Re: Montague Wind Power Facility Change Request #3 – Proposed Site Boundary and Transmission Line Route Modifications

Supplement to Change Request #3

Figure 1
Montague Proposed Modifications to
Approved Site Boundary and
230-kV Transmission Line Corridor
Montague Wind Power Facility -
Change Request #3

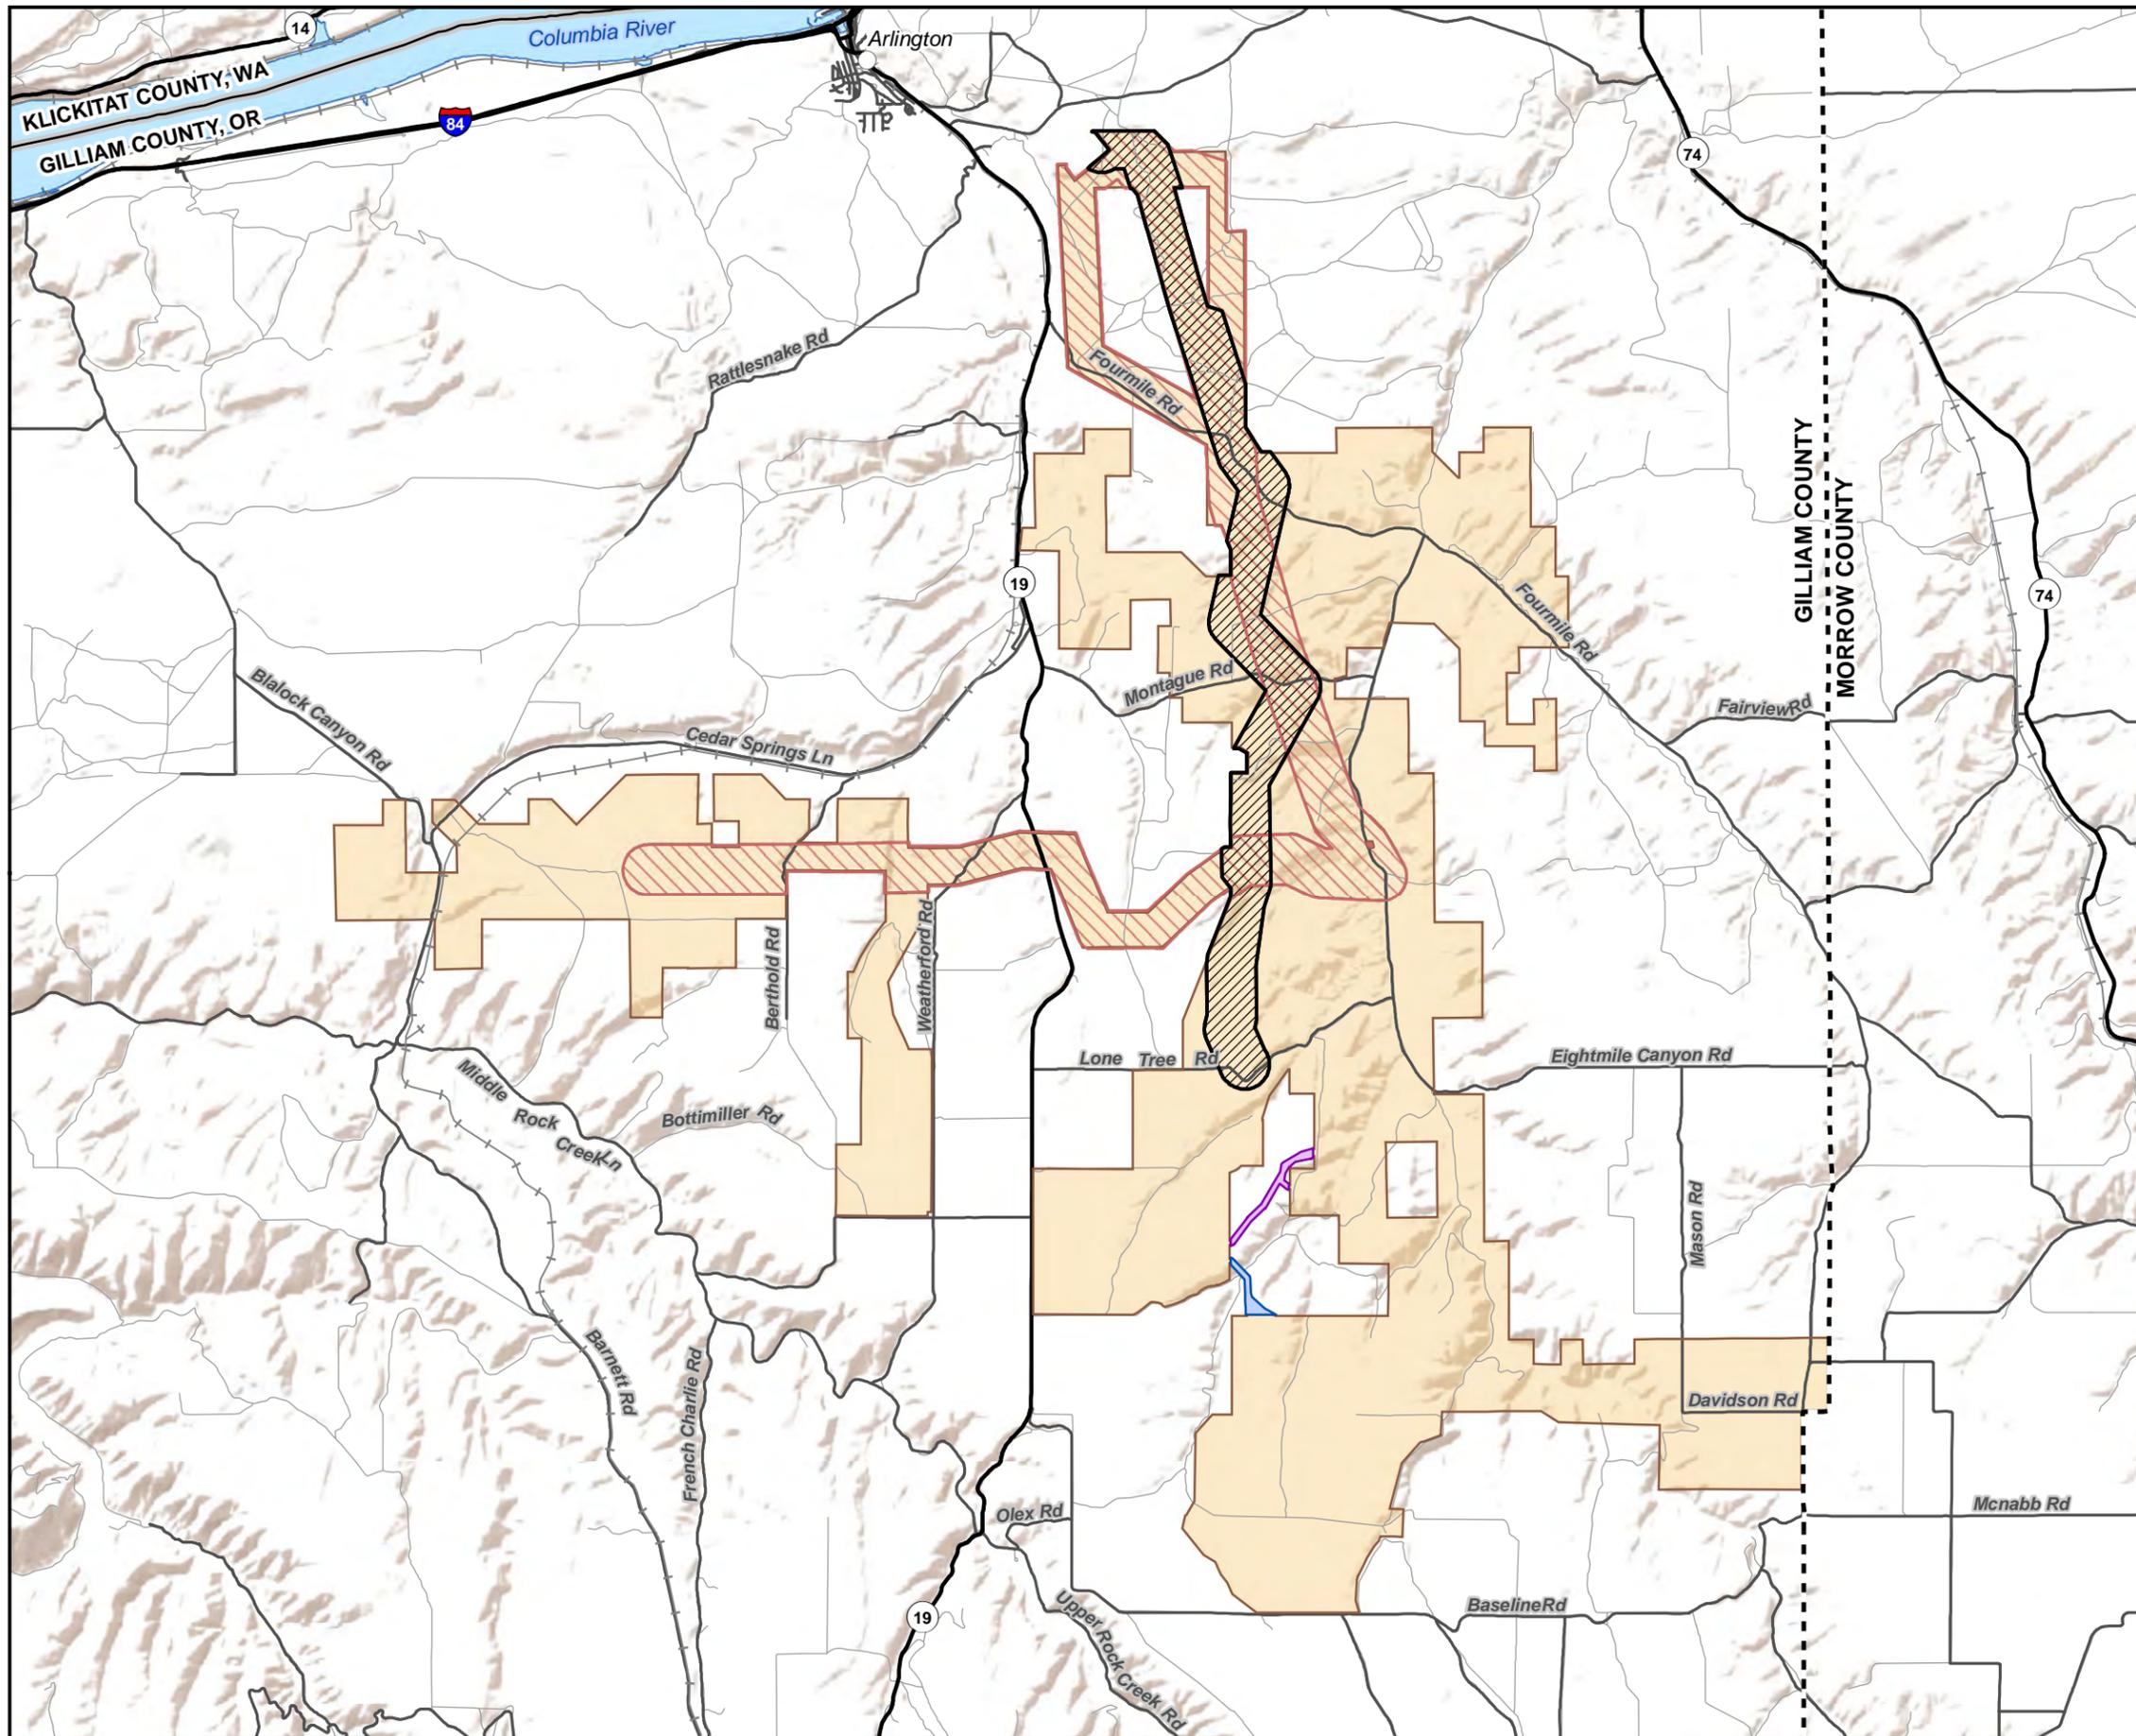
Montague Wind Power Facility, LLC (Montague) proposes two modifications to the previously approved Montague Wind Power Facility (Facility). These modifications are depicted on Figure 1 (located in the Attachment with other figures cited in this change request).

As shown in blue ("Collector Line") on Figure 1, Montague proposes to add 36.1 acres to the approved site boundary and micrositing corridor. The purpose of this addition is to reduce the length of overhead and underground collector lines required to connect turbines from the southern part of the Facility to the centrally located substation. The addition will allow Montague to construct a 3,300-foot segment of overhead collector line and multiple underground collector line segments, totaling 4,224 feet, which represents a reduction in length of the overhead collection lines between the southern turbines and the substation by nearly 2 miles.

As shown in purple ("Access Road") on Figure 1, Montague seeks to add 55.7 acres to the approved site boundary and micrositing corridor to allow construction of two road segments. The length of the turbine string access roads outside of the approved site boundary totals approximately 1 mile. This proposed modification will allow Montague to improve accessibility to turbine locations by avoiding the need to construct an access road on steep canyon slopes. Rather, Montague will follow existing farm roads and cross level ground, thereby reducing impacts to sensitive resources.

Figure 3
Land Use Map
 Montague Wind Power Facility -
 Change Request #3

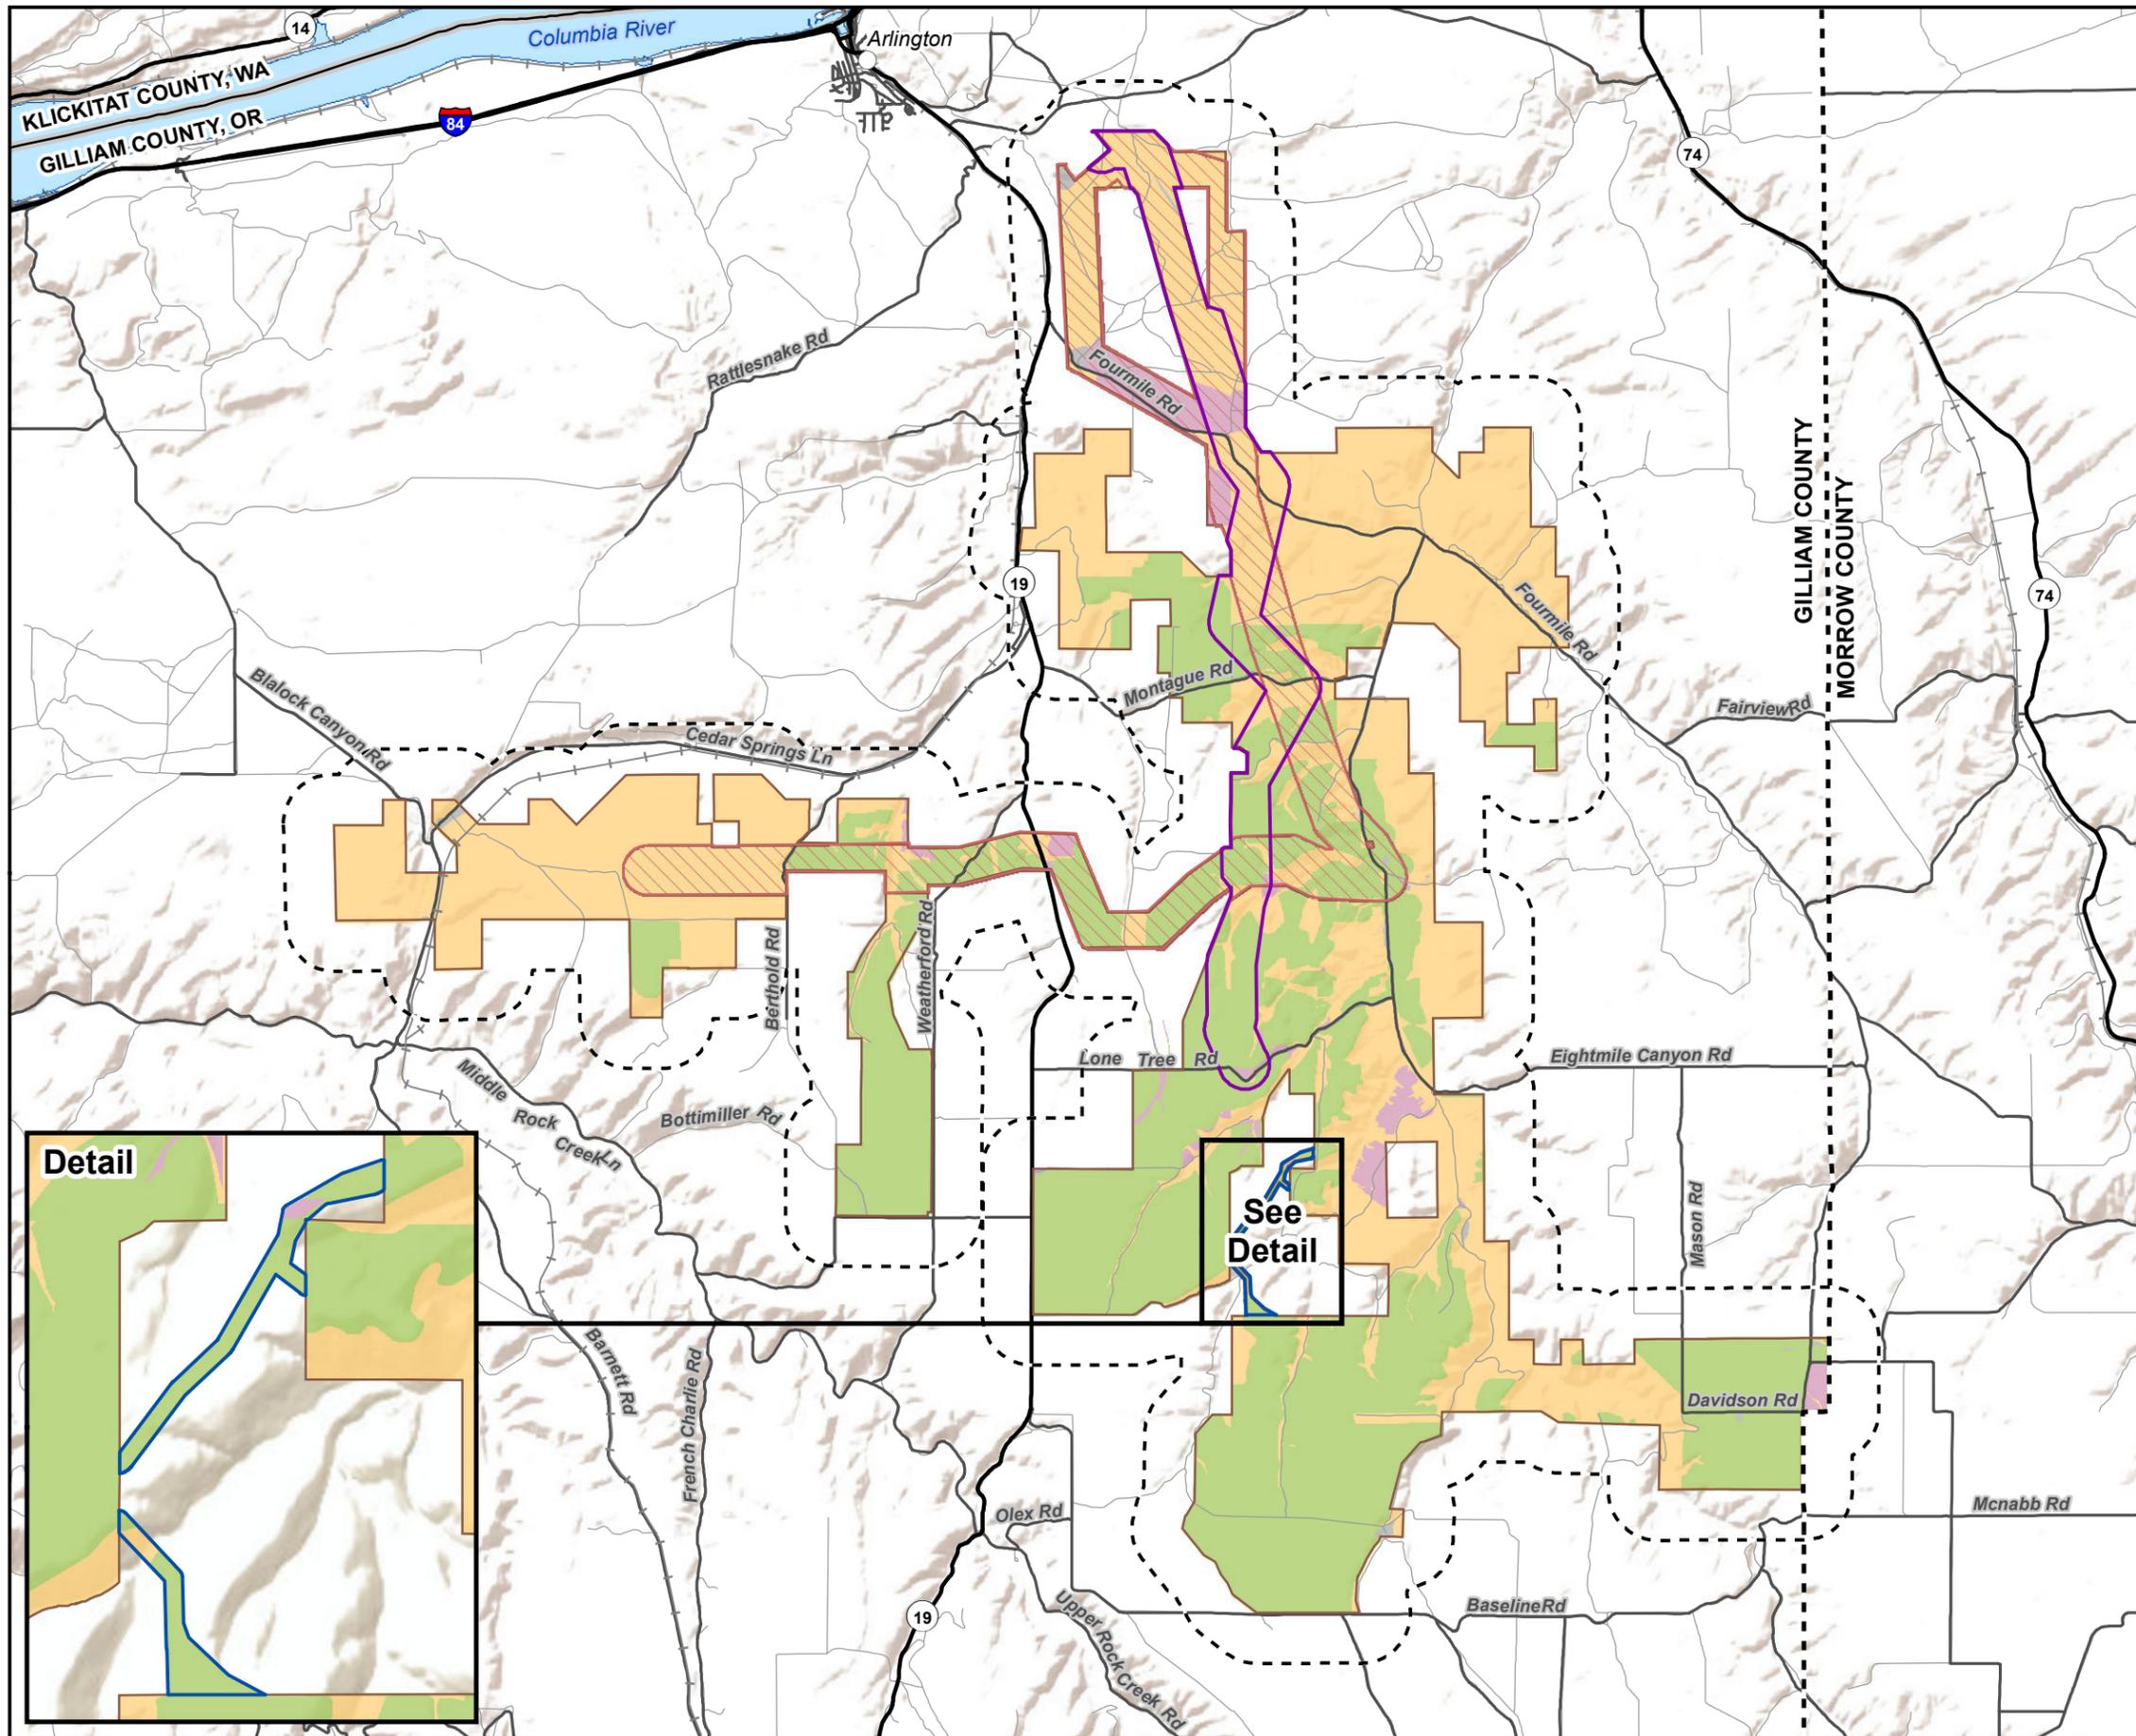
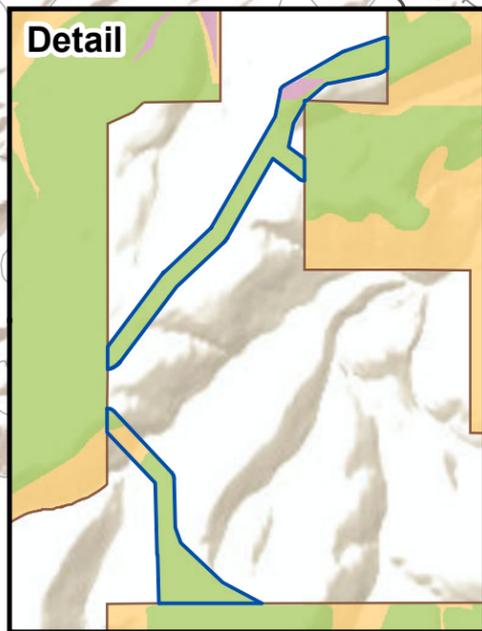
Based on review of Figure 3 of the change request, approximately 5 miles of the 10.5-mile transmission line route/corridor would be located within non-irrigated Class IV soils, or arable land. As presented on Figure 3 of the change request, there are areas outside of the proposed modified transmission line route/corridor, within the existing site boundary, comprised of non-irrigated Class VI soils or non-arable lands. The Department notes, however, that the areas of non-irrigated Class VI soils (non-arable lands) are heavily interspersed with non-irrigated Class IV soils (arable lands), limiting the technical and engineering feasibility of siting a reasonably direct route interconnecting the energy facility to the grid via BPA’s existing Slatt Substation. Moreover, the certificate holder explains that the proposed modified transmission line route/corridor was selected to provide a reasonably direct route from the centrally located collector substation to BPA’s existing Slatt substation, and has been sited based on geographic constraints of the area including gullies, ravines and steep slopes, which further limit the technical and engineering feasibility of alternate options on non-arable lands.
